# FY 2025-26 Standard Plans Update Training

Rick Jenkins, P.E  
State Standard Plans Engineer  
Roadway Design Office  
[Rick.Jenkins@dot.state.fl.us](mailto:Rick.Jenkins@dot.state.fl.us)

## STANDARD PLANS FY 2025-26 REVISIONS LOG

# Sheet 2: MUTCD Update

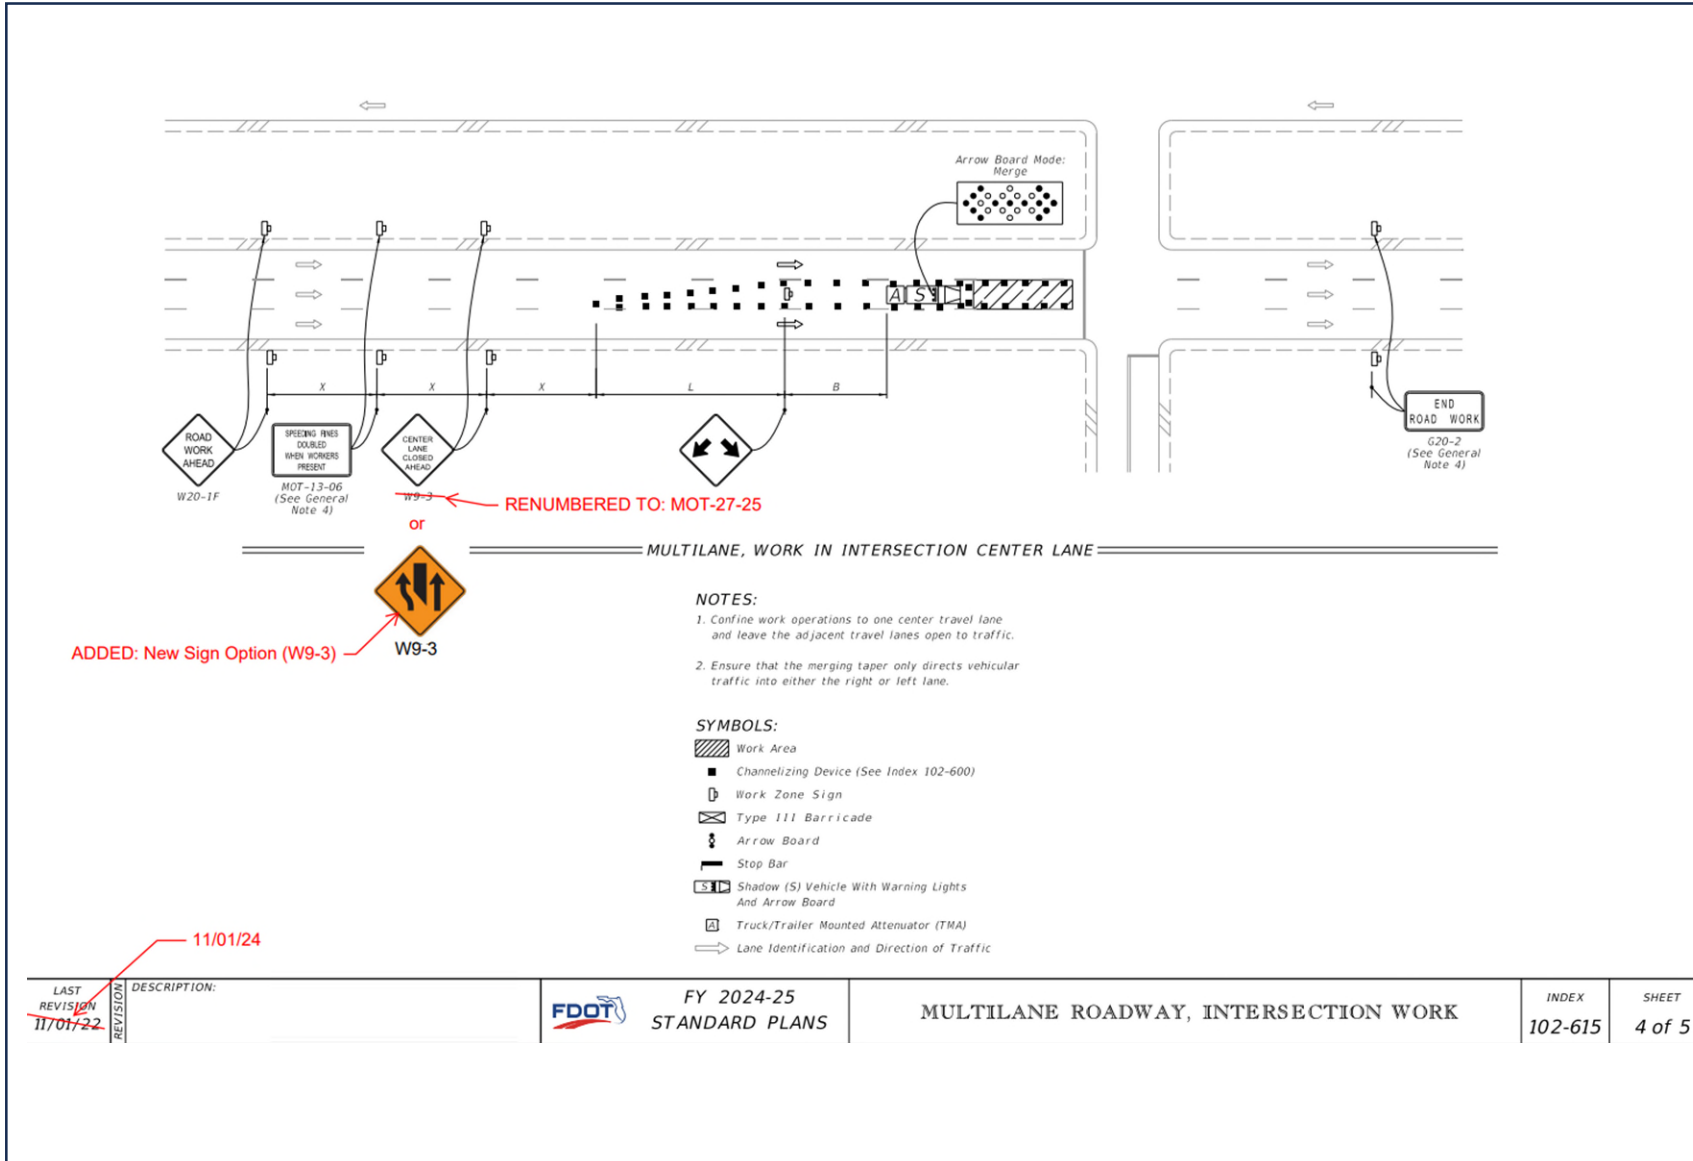
- Changed W16-1P sign to match MUTCD.

## Sheet 4: MUTCD Update

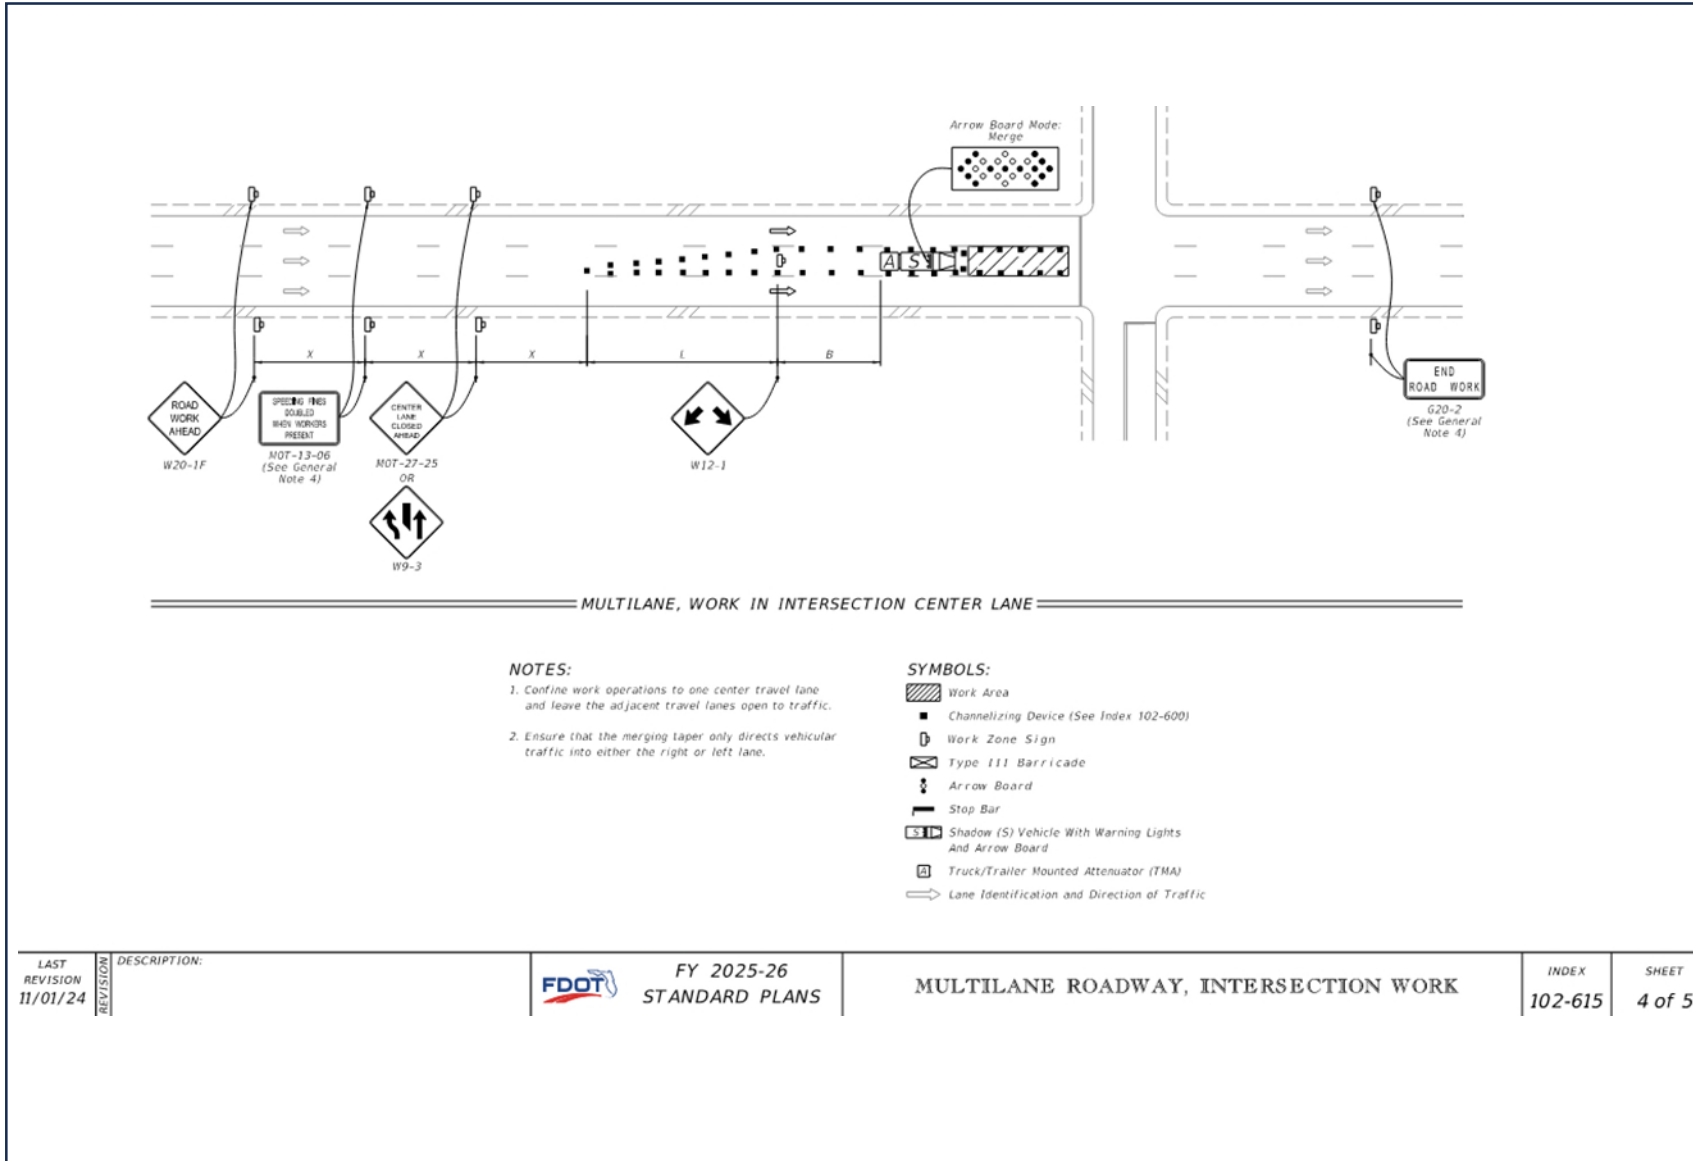
- Added new sign option (W9-3) under "Center Lane Closed Ahead" sign

## Sheet 1: MUTCD Update

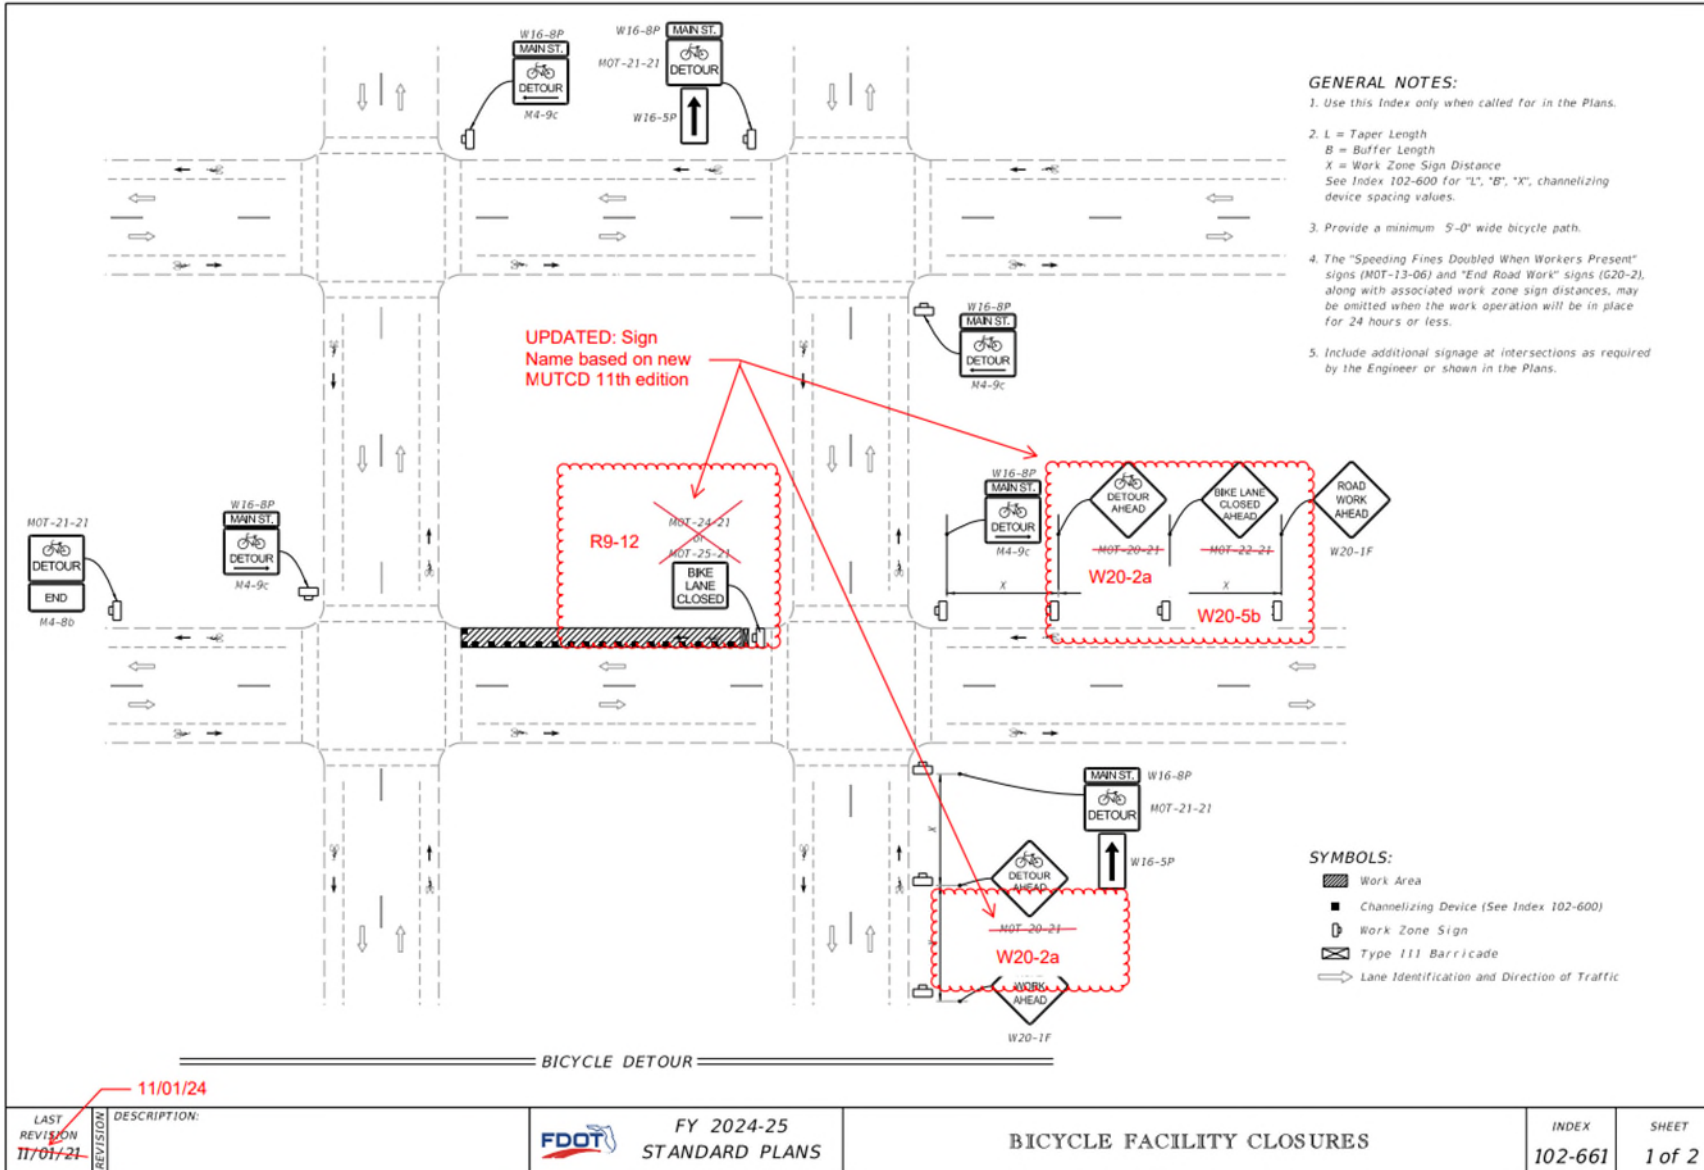
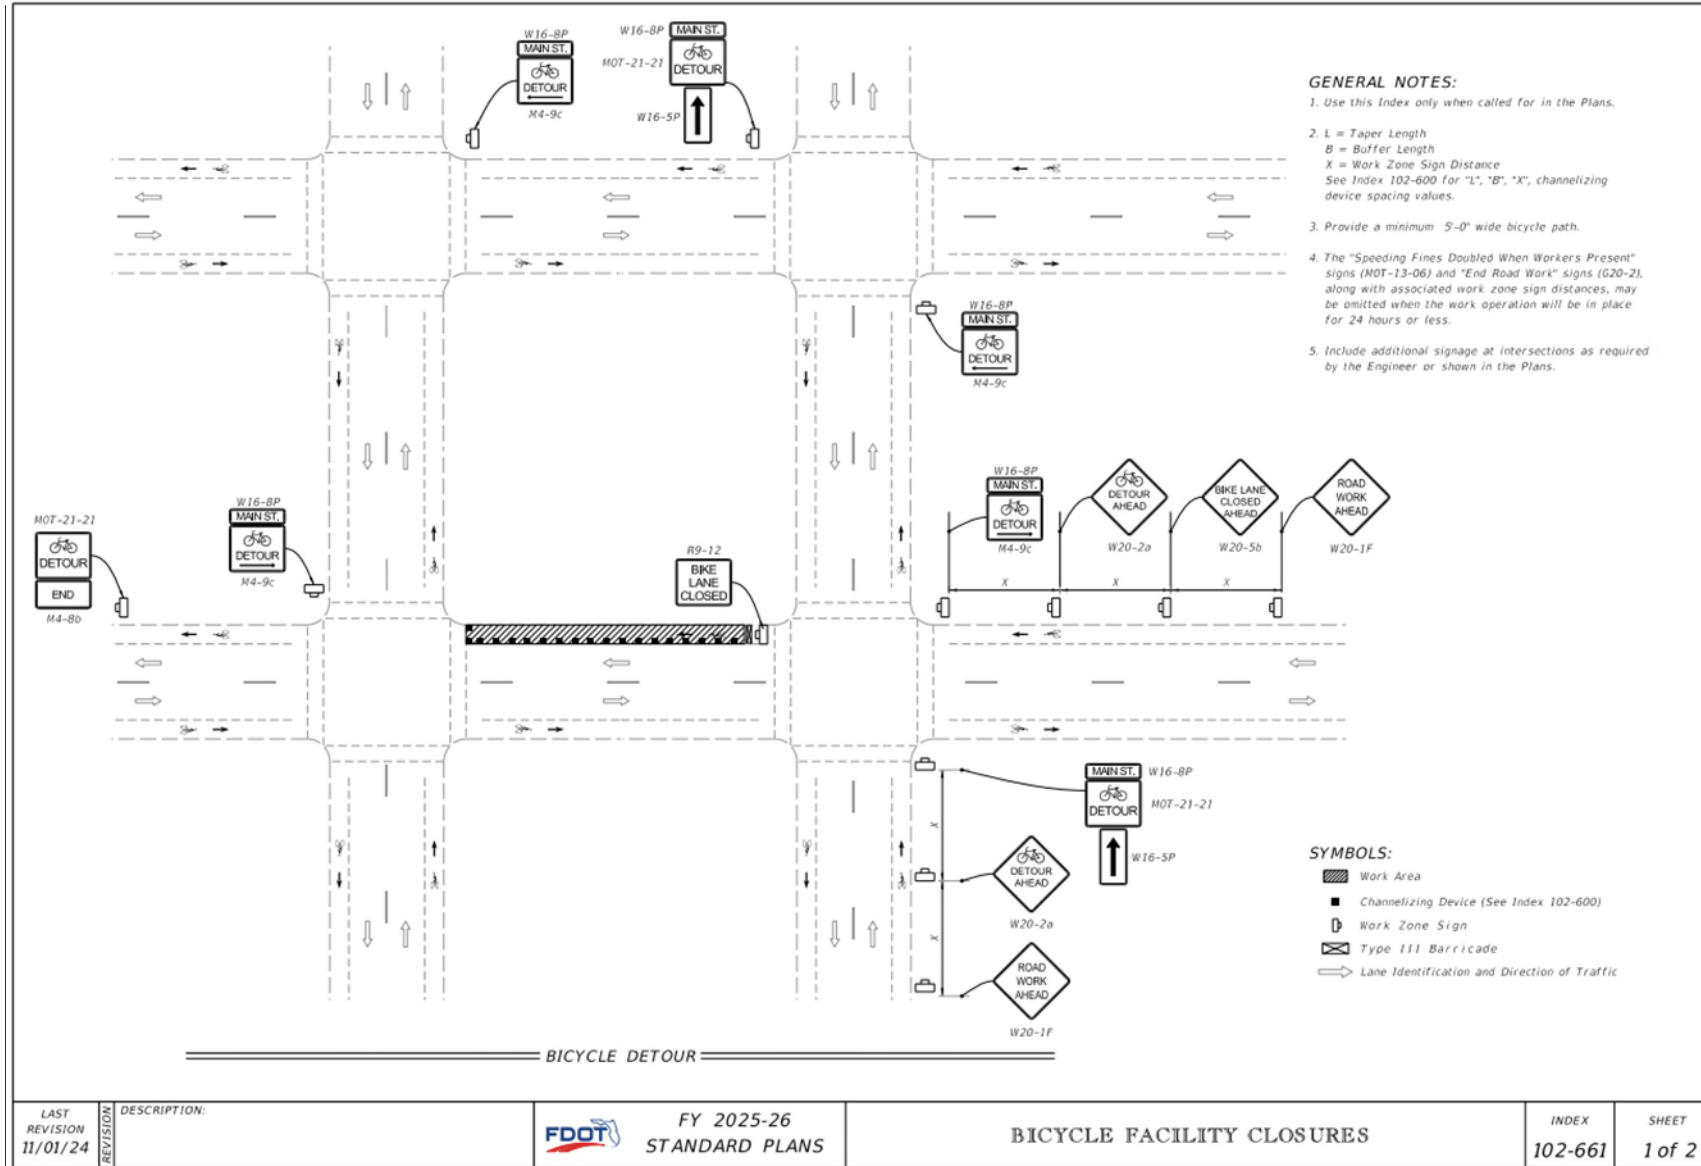
- Updated sign names based on new MUTCD 11th edition
